ATTACHMENT I

PROPOSED TECH. SPEC. CHANGES

CORE OPERATING LIMITS REPORT: CYCLE 6

ATTACHMENT II
PROPOSED WNP-2 CYCLE 6
CORE OPERATING LIMITS REPORT

Reduced Flow MCPR Operating Limit
This Curve Is Applicable to ANF Reload Fuel, GE Initial Core Fuel,
ANF 9 X 9 LFA Fuel, GE 11 LFA Fuel, and SVEA-96 LFA Fuel
This curve is also applicable to FFTR operation
Figure 3.2.3-1

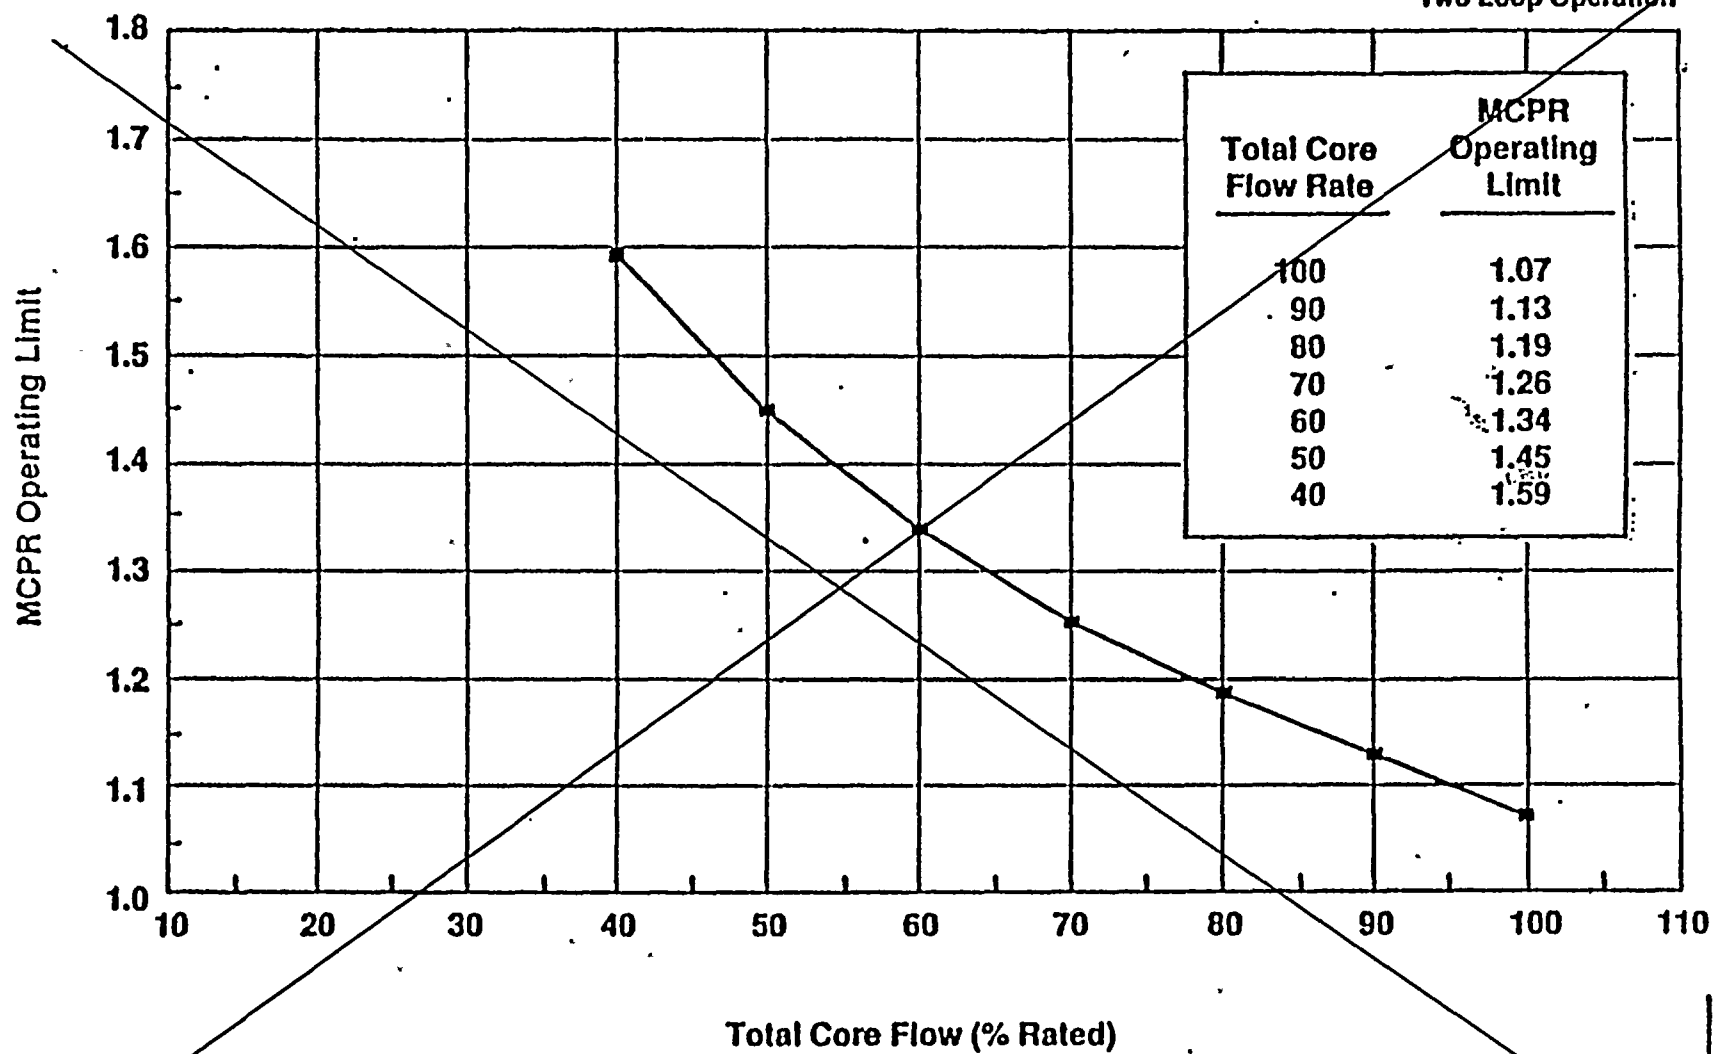
ACTION: With MCPR less than the applicable MCPR limit ~~determined from Table 3.2.3-1 and Figure 3.2.3-1~~ *the Core Operating Limits Report*, initiate corrective action within 15 minutes and restore MCPR to within the required limit within 2 hours or reduce THERMAL POWER to less than 25 percent of RATED THERMAL POWER within the next 4 hours.

4.2.3.1 MCPR shall be determined to be greater than or equal to the applicable MCPR limit ~~determined from Table 3.2.3-1 and Figure 3.2.3-1~~ *from the Core Operating Limits Report.*

FLOW DEPENDENT SPECIFIED IN THE CORE OPERATING LIMITS REPORT
The purpose of the MCPR_f of Figure 3.2.3-1 is to define operating limits at other than rated core flow conditions. At less than 100% of rated flow the required MCPR is the maximum of the rated flow MCPR determined from Table 3.2.3-1 and the reduced flow MCPR determined from Figure 3.2.3-1. MCPR_f assures that the Safety Limit MCPR will not be violated. MCPR_f is only calculated for the manual flow control mode. Automatic flow control operation is not permitted. BOTH SPECIFIED IN THE CORE OPERATING LIMITS REPORT.

Figure 3.2.4-1

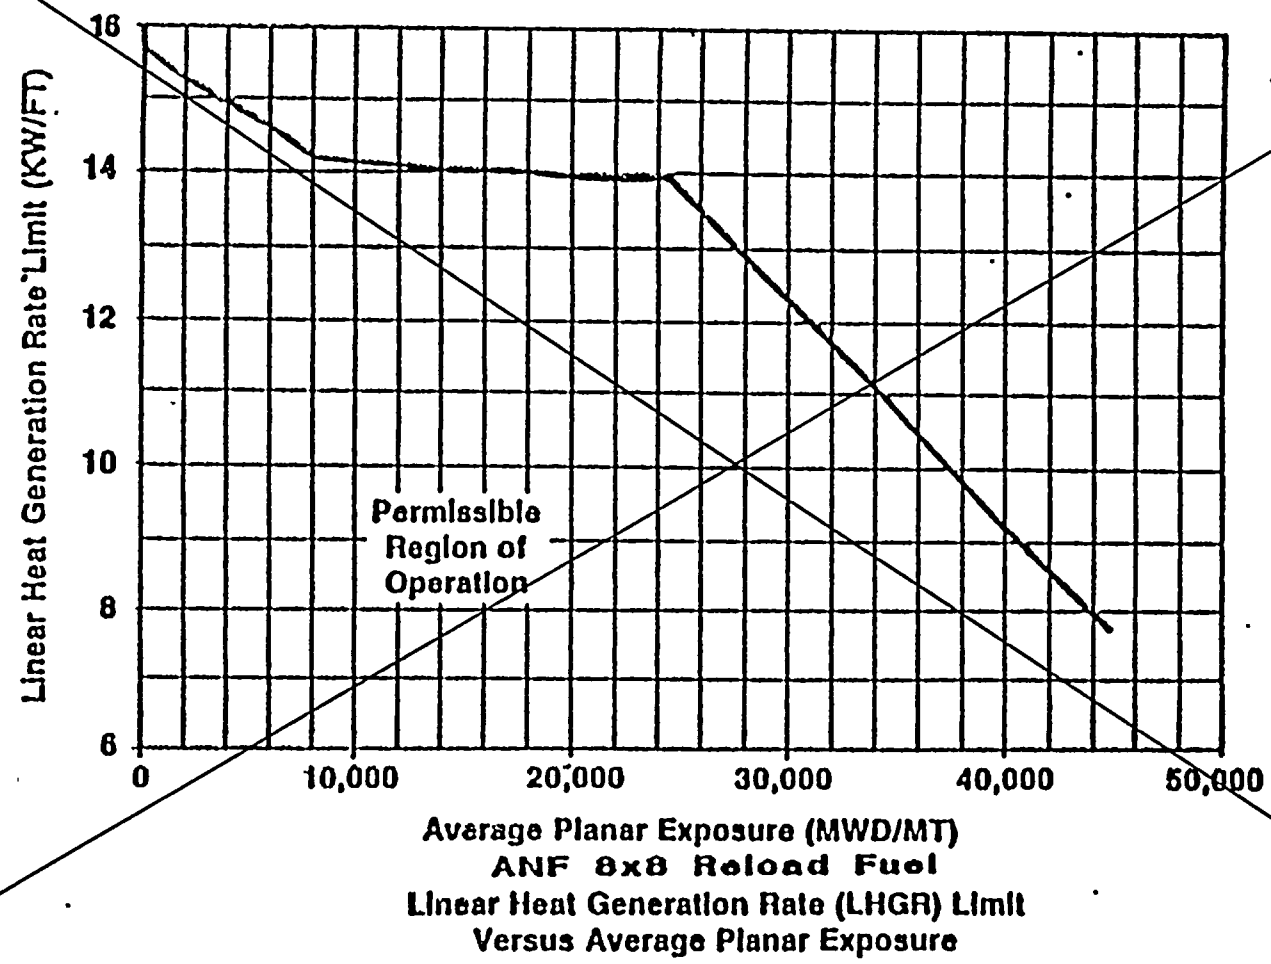
3.2.4 The LINEAR HEAT GENERATION RATE (LHGR) ~~for GE initial core fuel shall not exceed 13.4 kW/ft. The LHGR for reload fuel shall not exceed the values shown in Figures 3.2.4-1, 3.2.4-2, 3.2.4-3, 3.2.4-4 and 3.2.4-5. The Core Operating Limits Report~~
